PLAN COMMISSION MEETING AGENDA

TUESDAY, January 14, 2014
AT 6:00 P.M.

Plan Commission Report

SHEET TITLE
Site Plan

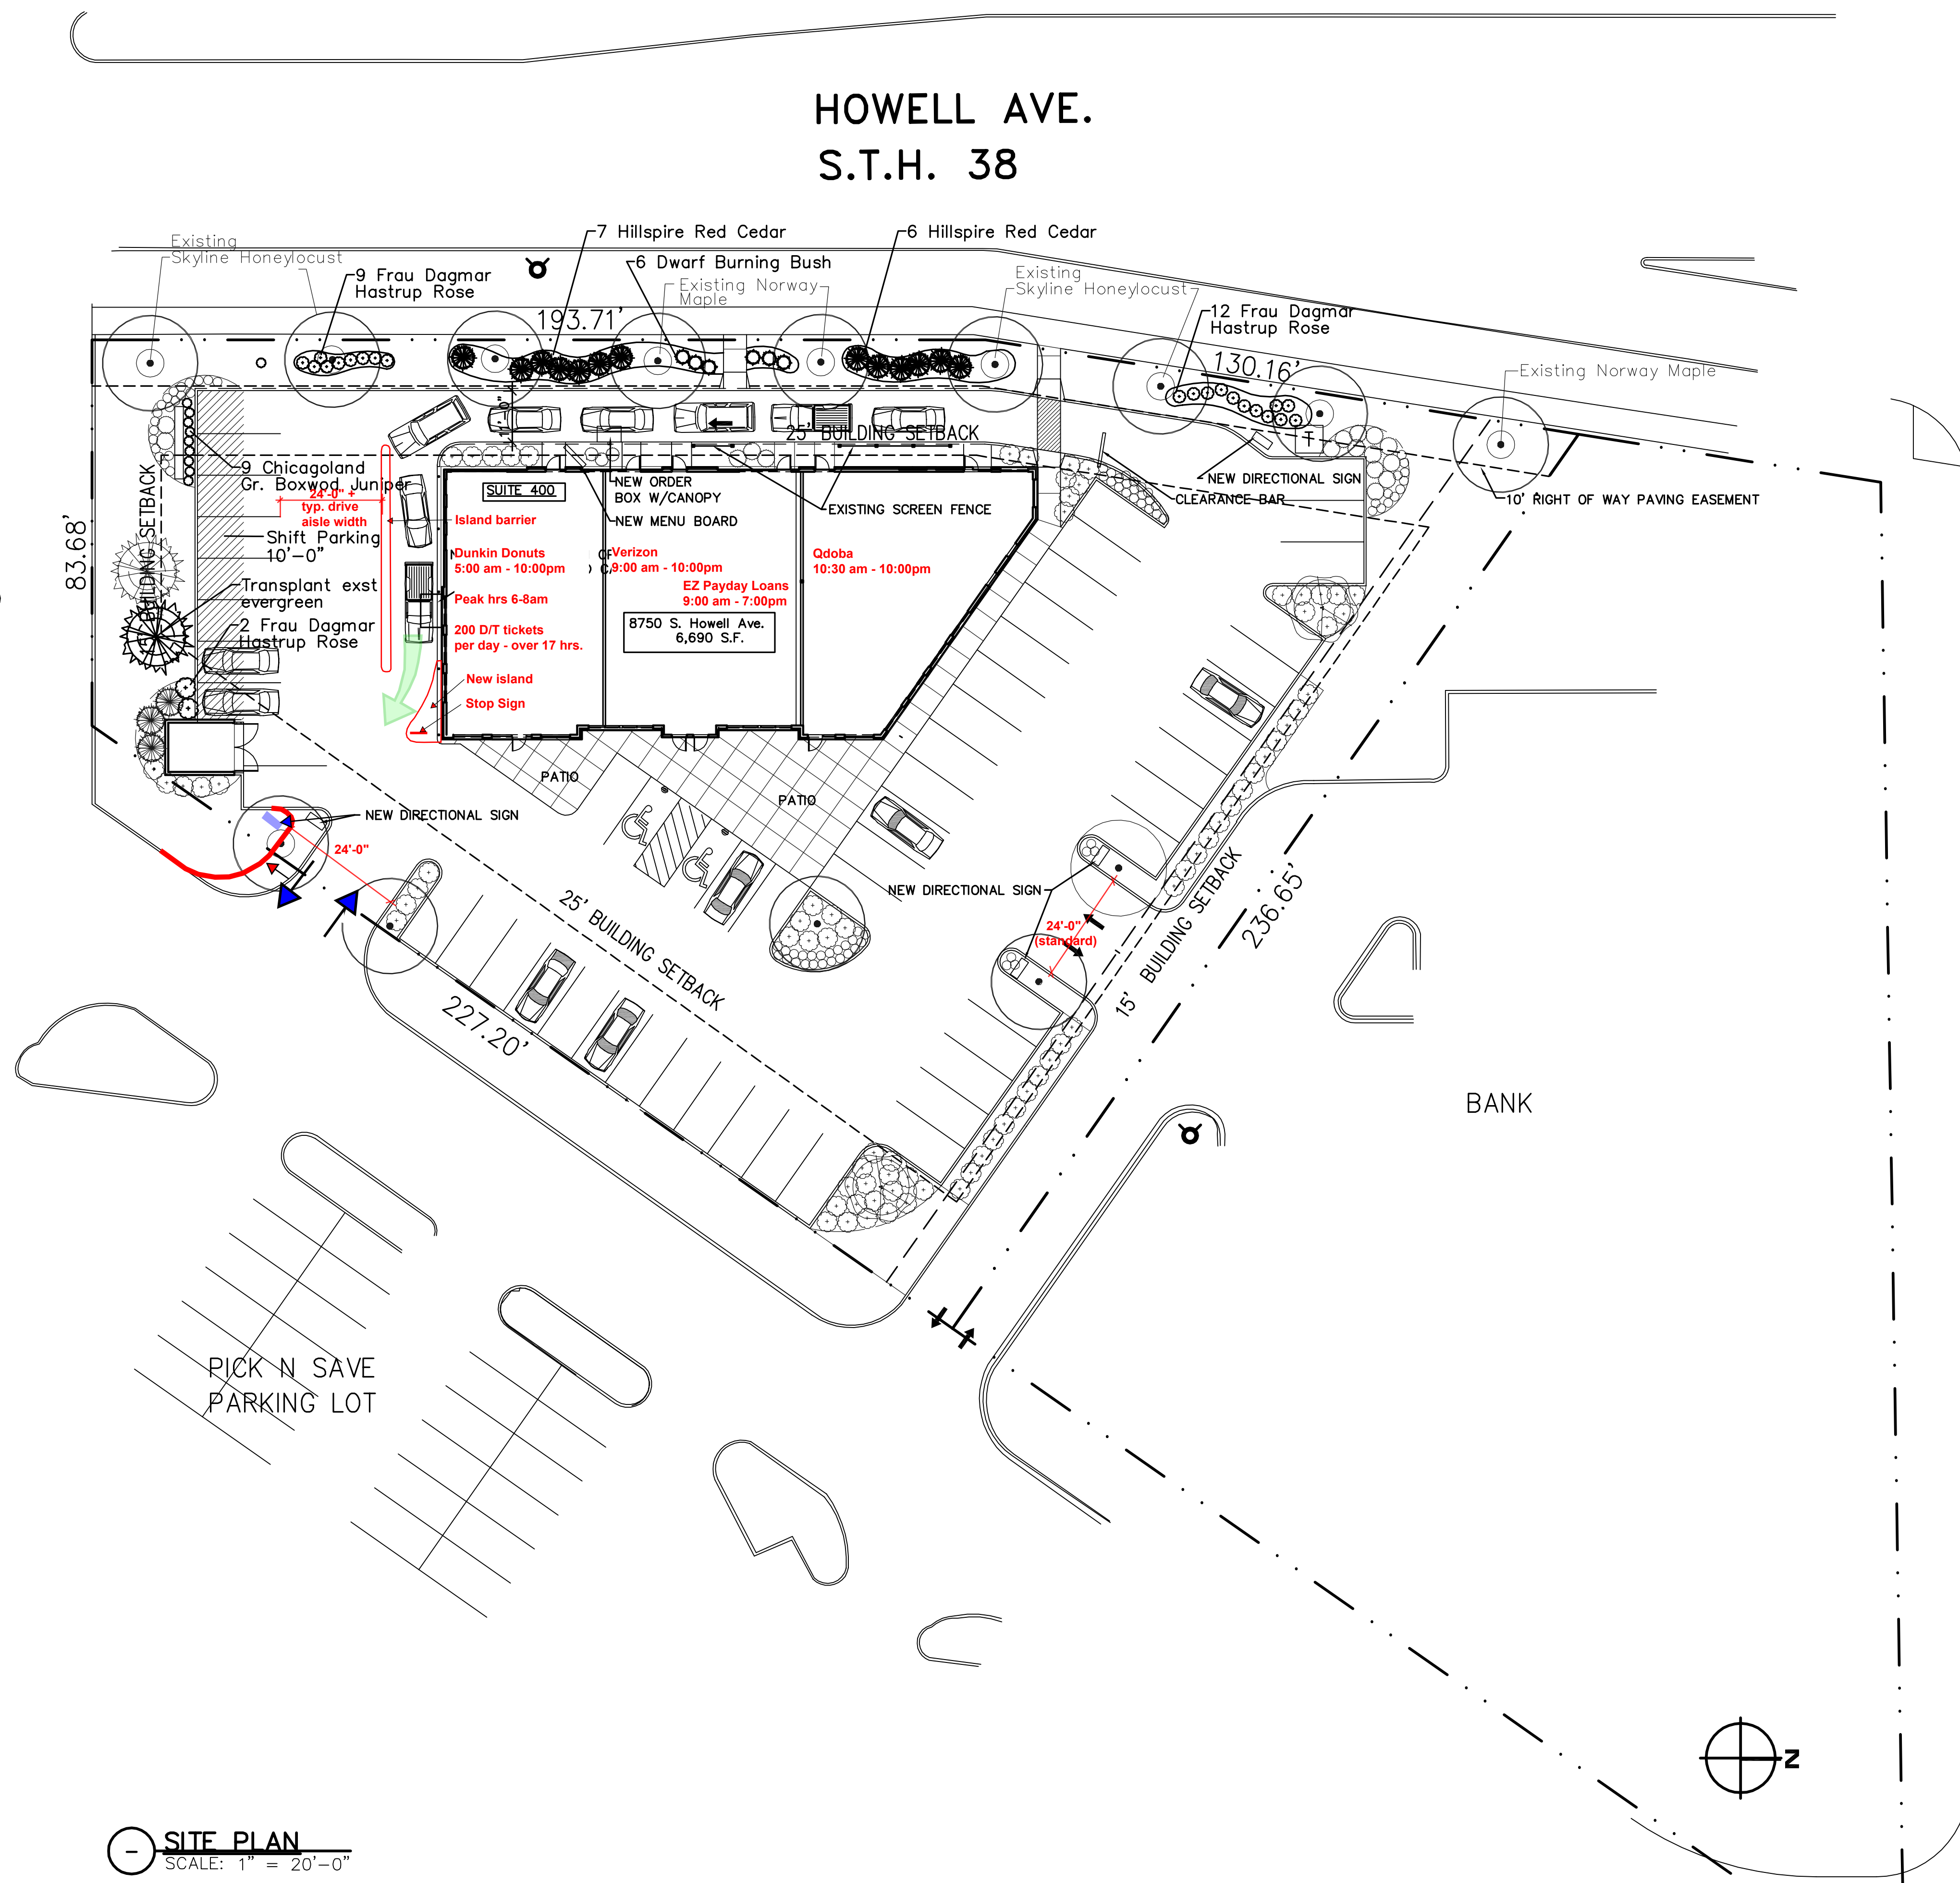
Commentary: This item was held at the December 10, 2013 meeting due to concerns for site circulation and safety and parking. Updated plans have been submitted and are included in this packet. In addition to installing a stop sign at the southeastern corner of the building and widening the eastern entrance to 24 feet as proposed at the December 10, 2013 meeting, the Applicant is proposing to add an "island barrier" to separate the parking stalls from the drive-through lane and another island between the window and the southeastern corner of the building. A directional sign will alert motorists to the right-turn circulation pattern for the site (i.e., no left-turn from the southern entrance). There are no further changes from the plans reviewed on December 10.

Staff continues to be concerned for site circulation with the revised plan. The proposed island barrier does not appear to allow enough clearance for the drive-through turning radius at the southwest corner of the building. When combined with the proposed island at the southeastern corner of the building, the island barrier does not appear to allow enough maneuvering room for a larger vehicle to pass from the drive-through to the rest of the site. Staff also recognizes that there are no dimensions for either island proposed, and that plowing with this configuration will be difficult. However, staff feels that these issues can be

This item was held at the November 26, 2013 meeting due to several concerns raised by the Commission for site circulation and safety. Updated plans have been submitted and are included in this packet. The Applicant proposes to add a stop sign and speed bump at the southeast corner of the building, and widen the eastern entrance to 24 feet. Widening the entrance will eliminate the parking stall immediately east of the trash enclosure and will allow for greater maneuverability in that area.

SITE PLAN

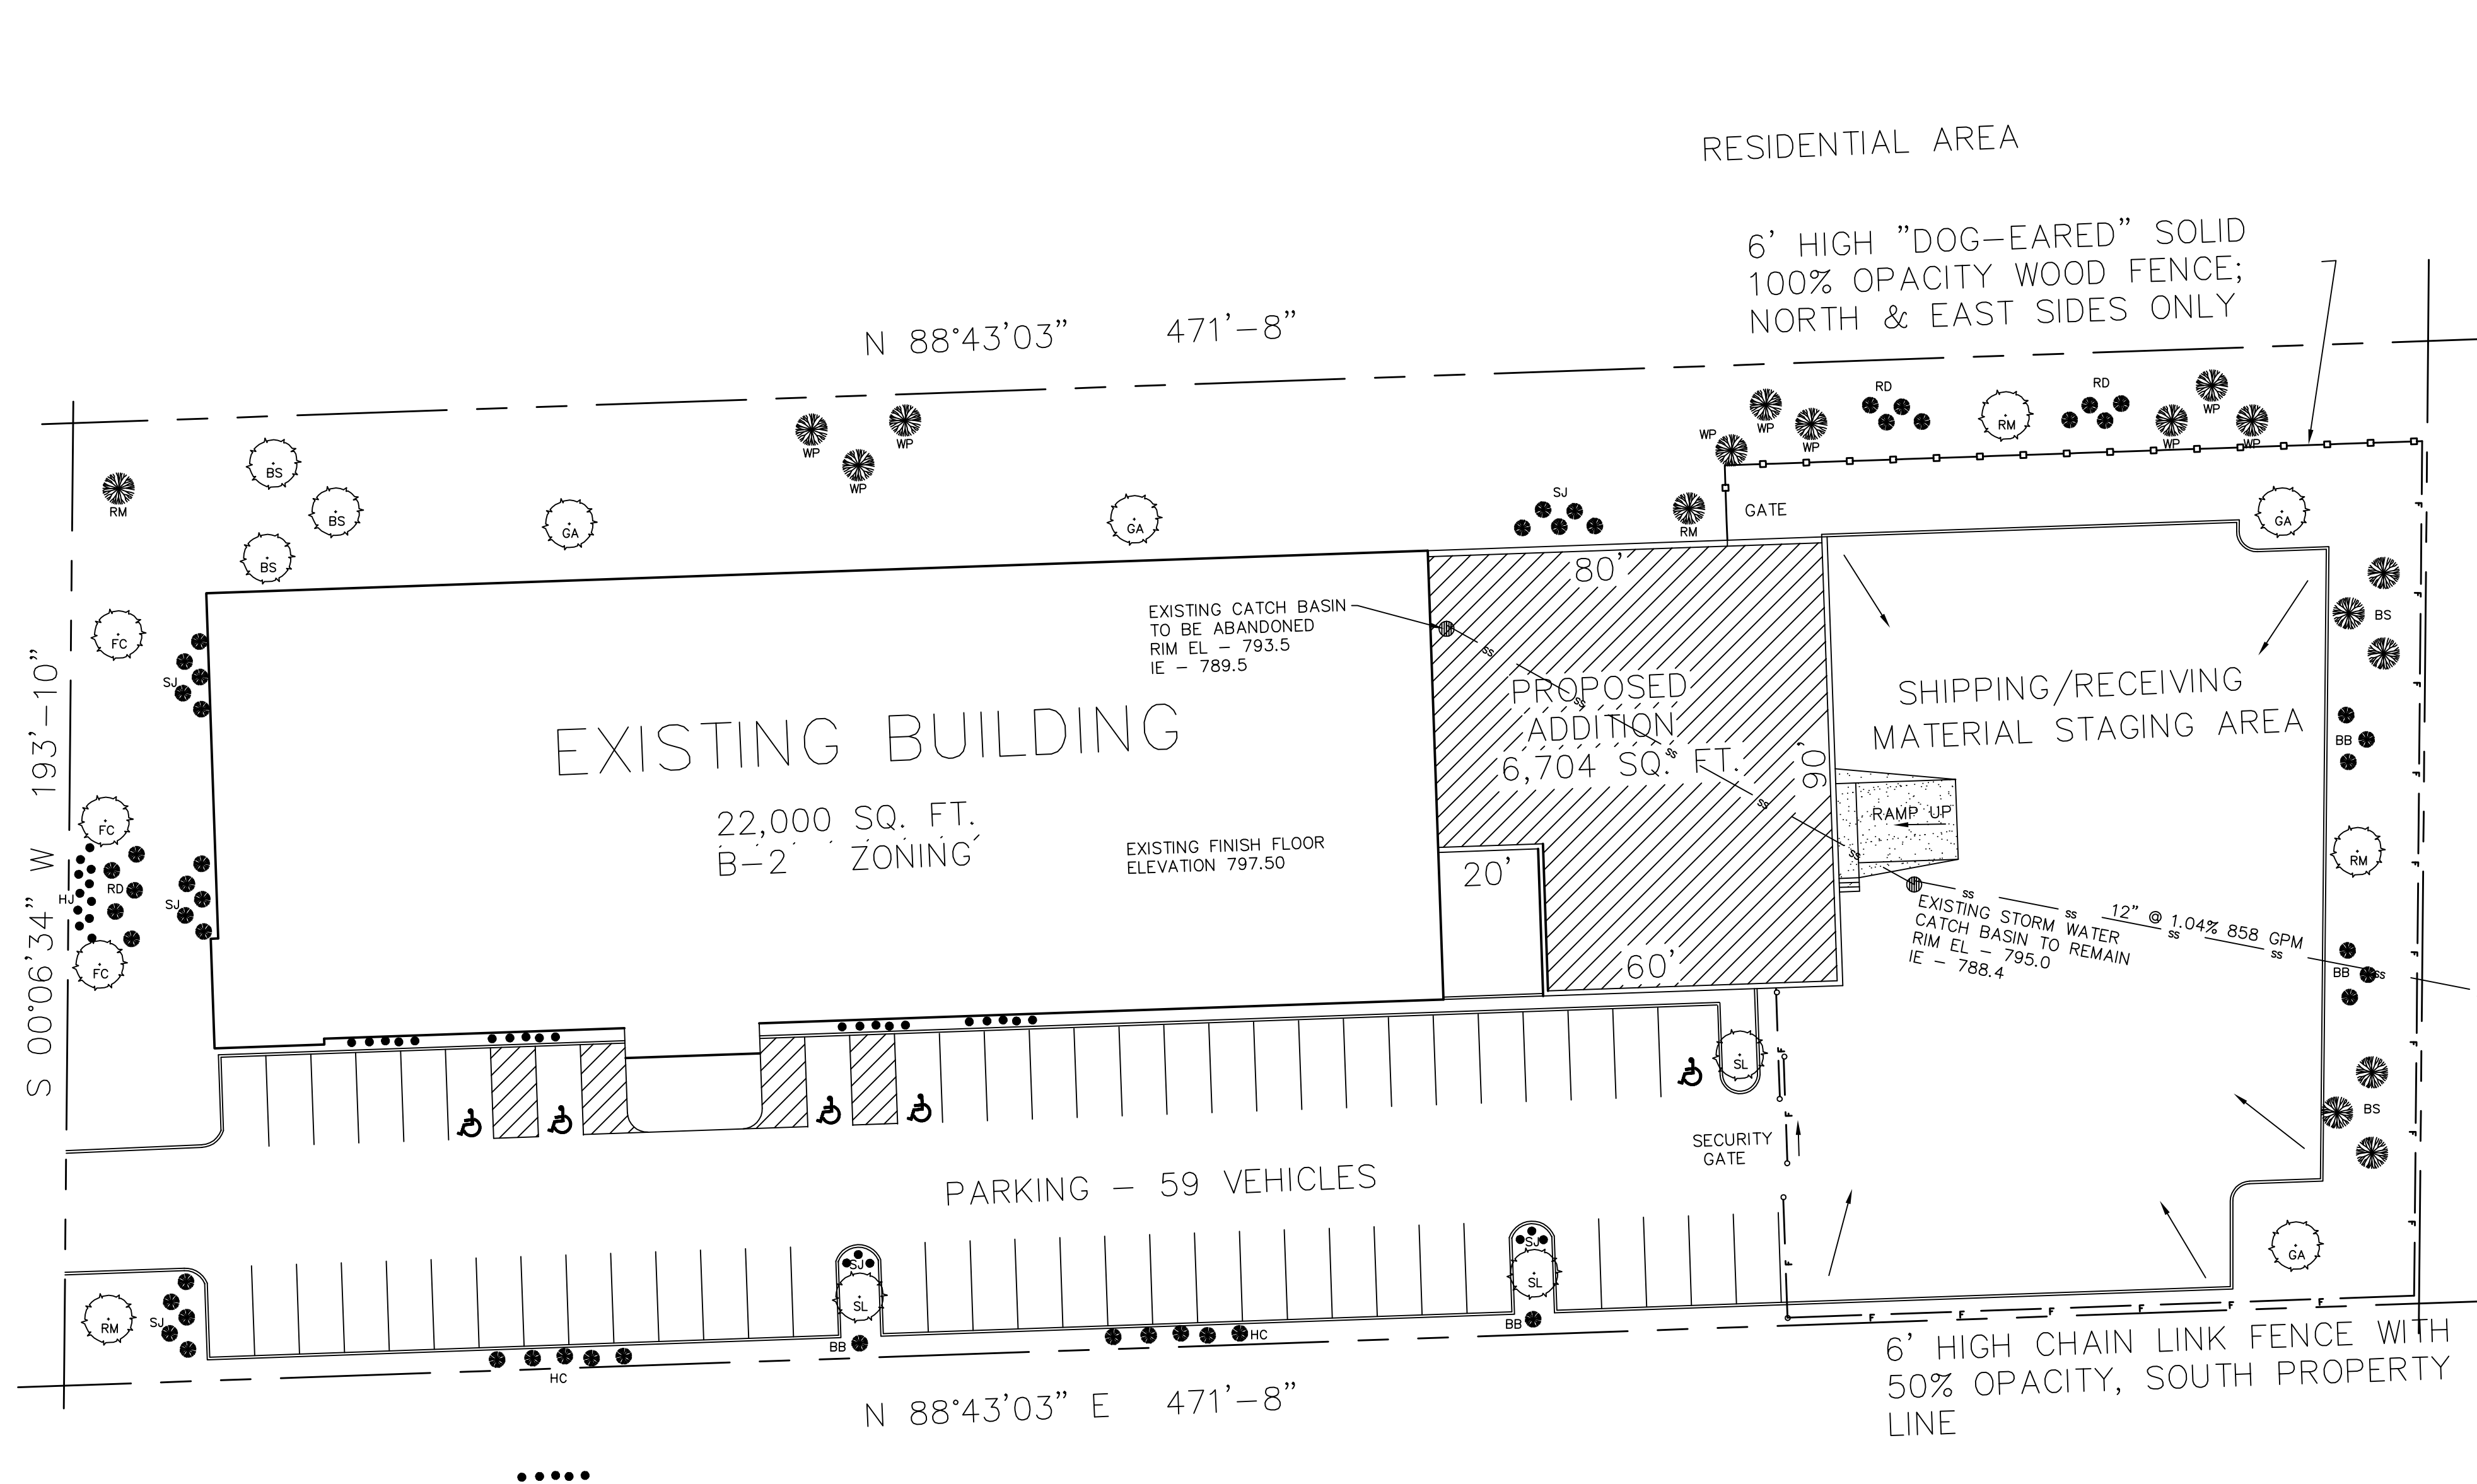
Commentary: Wisconsin Granite Depot is requesting approval of a 6,704 square-foot addition onto the eastern portion of the existing building at 6720 S. 27th St. Plan Commissioners will recall that the Conditional Use Permit for this property required the submission of an application for an addition to the building within one year of approval.

The addition will serve as supplementary warehouse space for the business, and includes one new loading dock (facing the east). The addition meets all required setbacks and will be constructed with split-face concrete block to match the existing building. While only a portion of the addition will be hidden behind the existing fence, the loading dock area will be completely screened from the northern and eastern property lines. No public access is proposed behind the fence and no changes to the existing parking are proposed. Landscaping will be provided as per the plans approved by the Plan Commission on May 23, 2000 and September 24, 2013.
